OLDHAM ROAD

NON-MATERIAL AMENDMENT REPORT

D464-TGA-RP-FI_90_72-0001

31.03.23

ELEVATIONS - OLDHAM ROAD

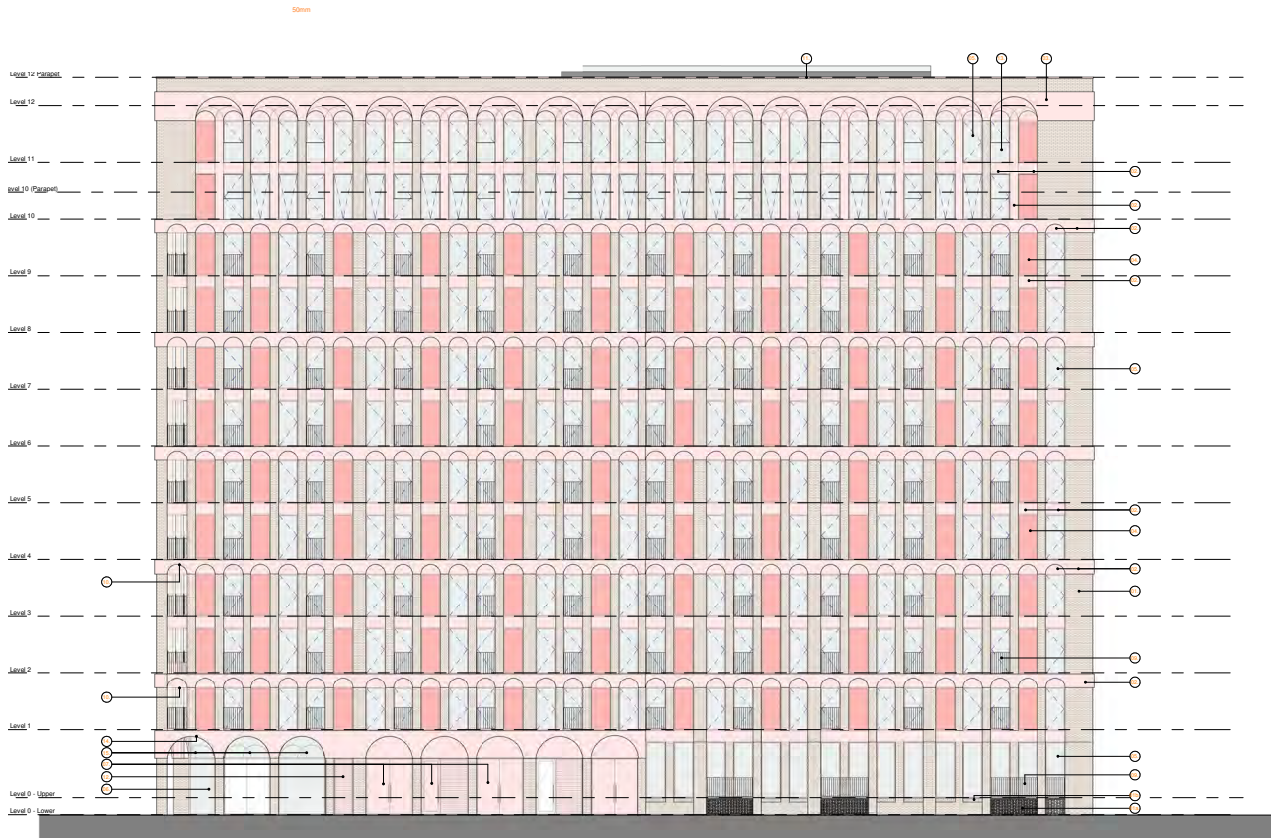
Proposed alterations to Oldham Road elevation;

- Restricted opening windows to be replaced with juliet balconies for improved amenity
- Windows, juliet balconies and spandrel panels to be redistributed across the facade
- Skylight and associated smoke vent developed at detailed design
